工程指示 / 要求簡箋(E.I.)

工程指示編號：EI / 5527 / 23 (原 EI 5272) 修改版次：M

工程名稱：將軍澳日出康城 LP 11

工程項目：幕牆 大貨單元件加工圖

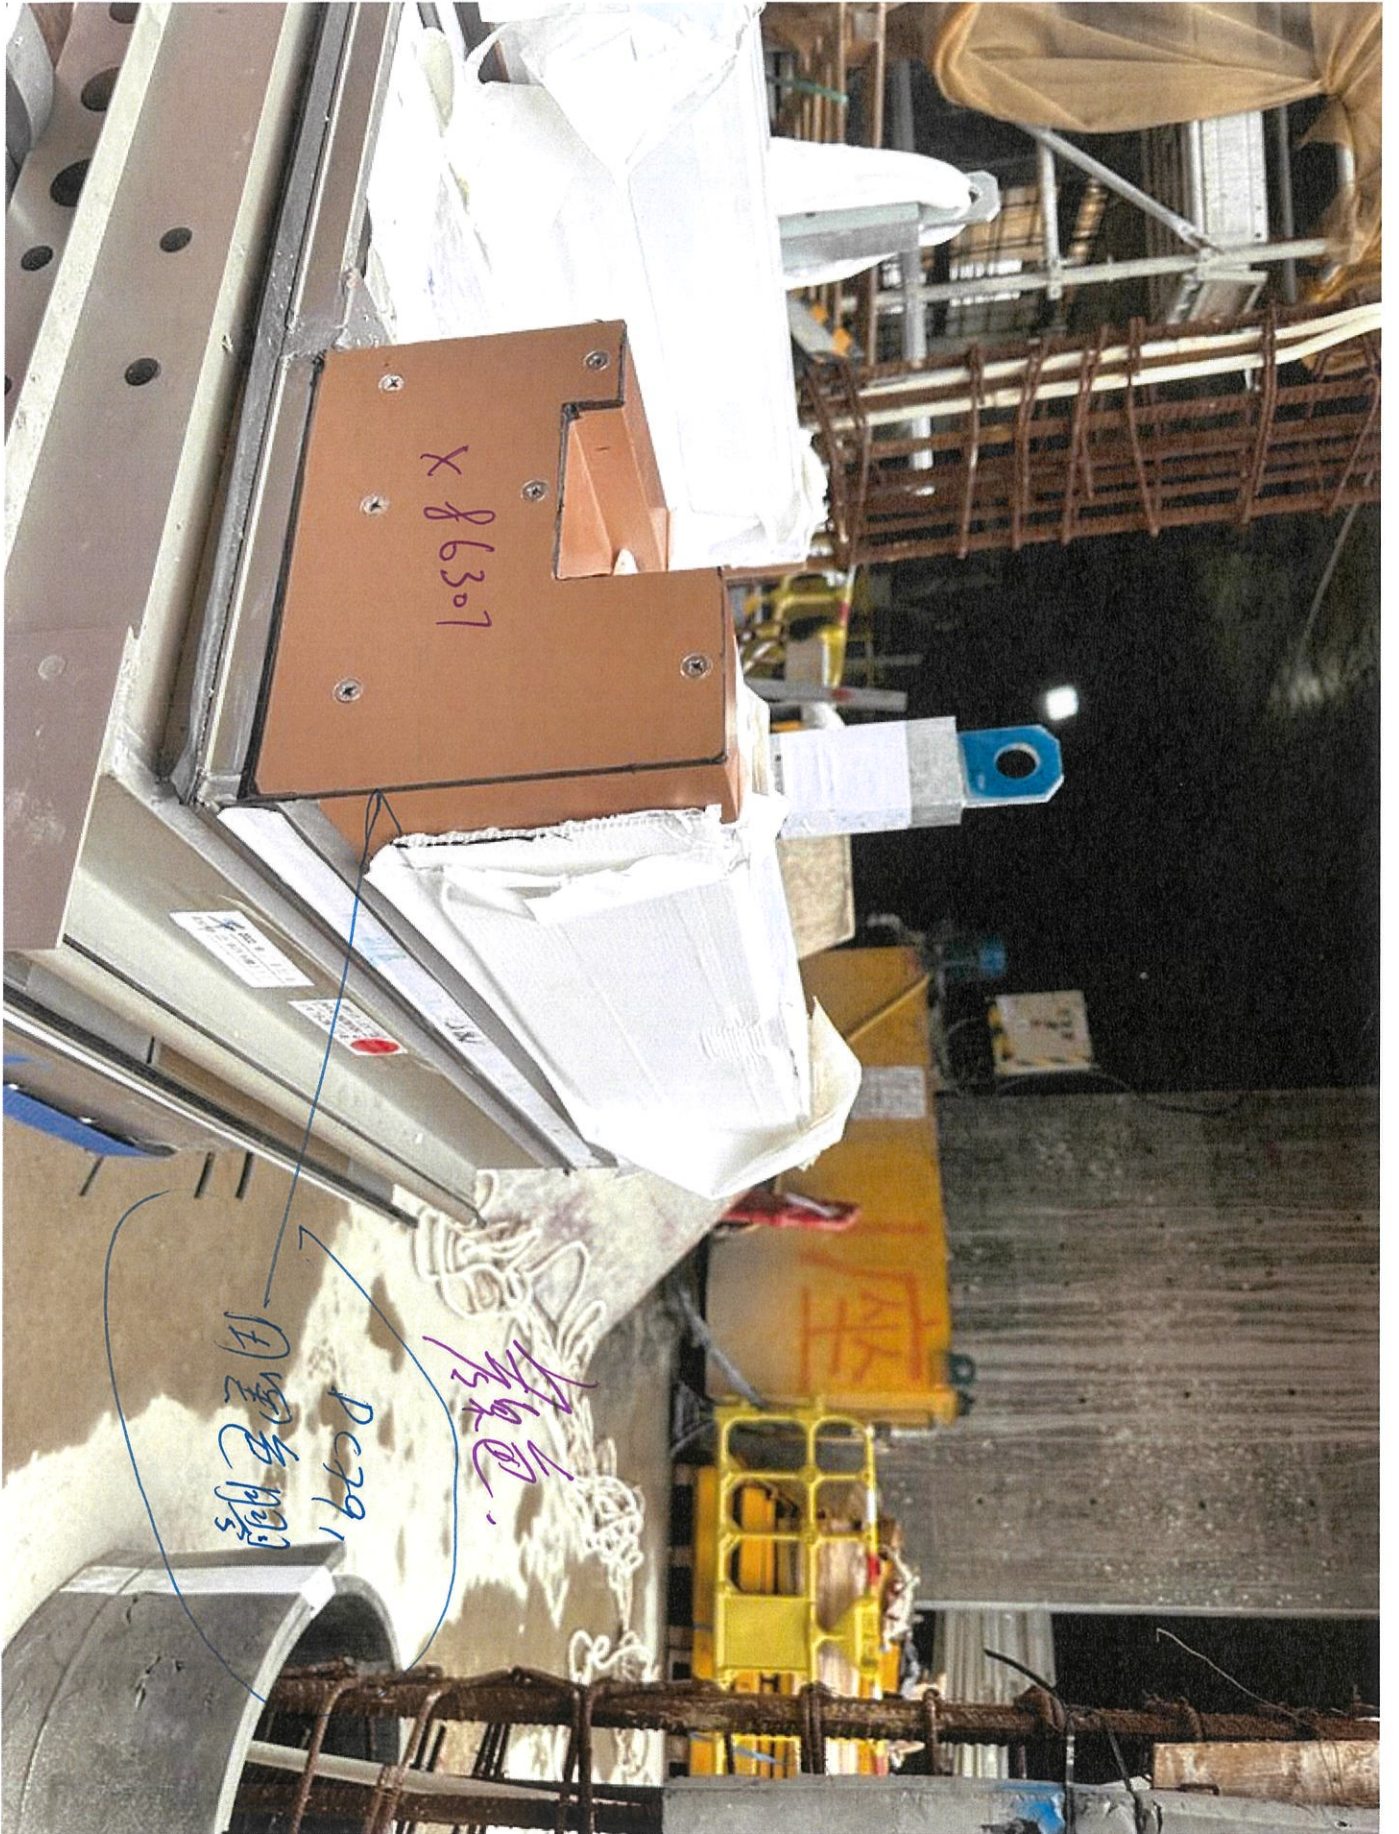
L 版：因應地盆安裝時，原本在地盆安裝的防火棉托，會阻礙安裝有飾線的單元件。

所以凡有飾線的單元件此防火棉需改由廠安裝。顧問已同意。(附報告)

L *請留意 防火棉需貼上錫紙，錫紙包好完整，不露出防火棉。

參考相片，該個飾線背空間全裝密，單元背凸出 30MM 便可以，唔夠地盤後補。

1 TYPICAL TRANSOM DETAIL
 D51 CURTAIN WALL

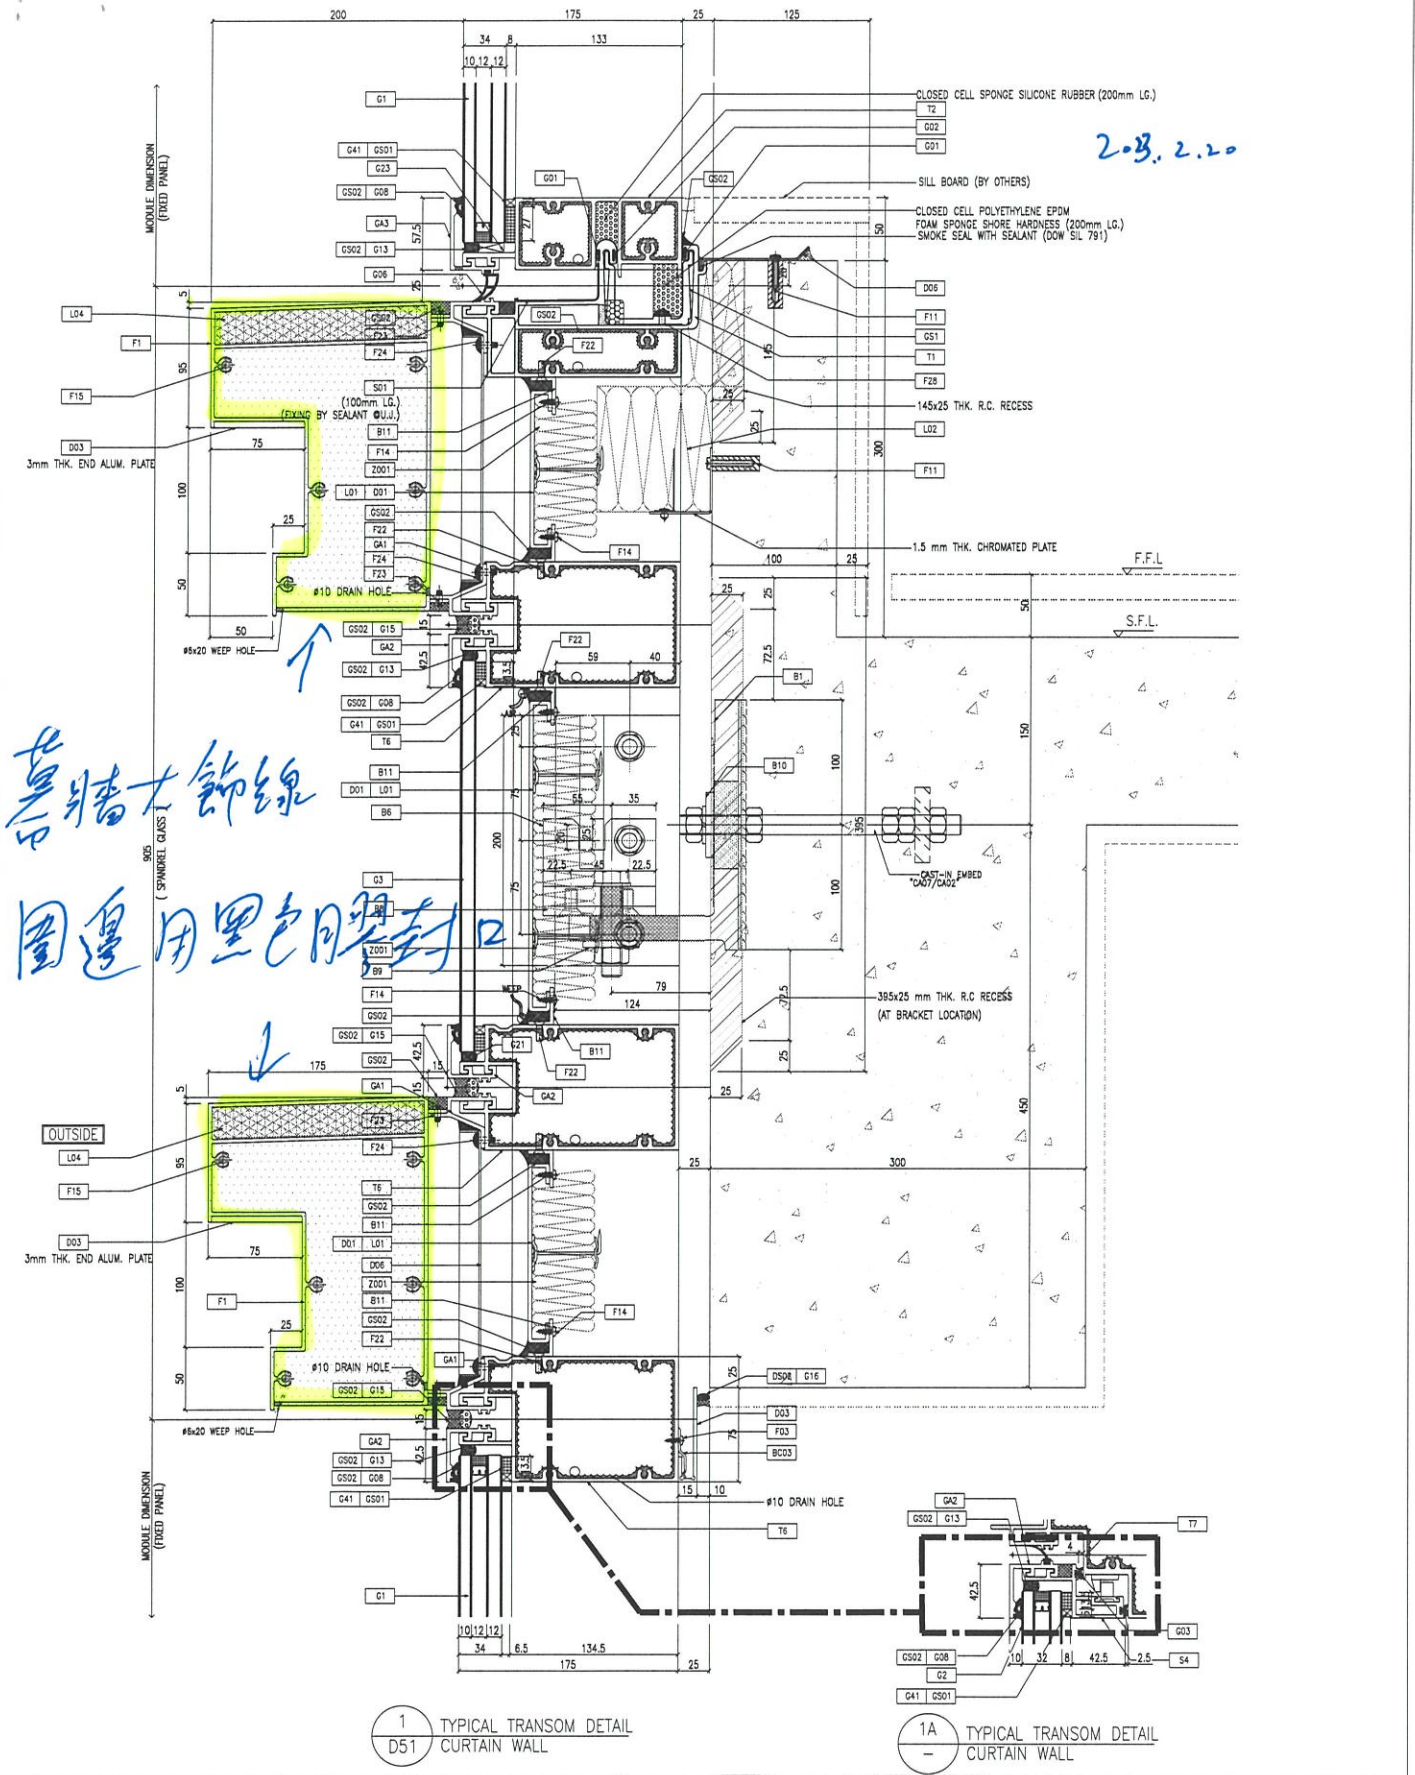
→ M 版：因應業主要求飾線收封口片後圍邊啣黑膠 DC791。注意：膠不要太粗 (已附電郵確認)

幕墙大節線
 圈邊用黑色膠密封
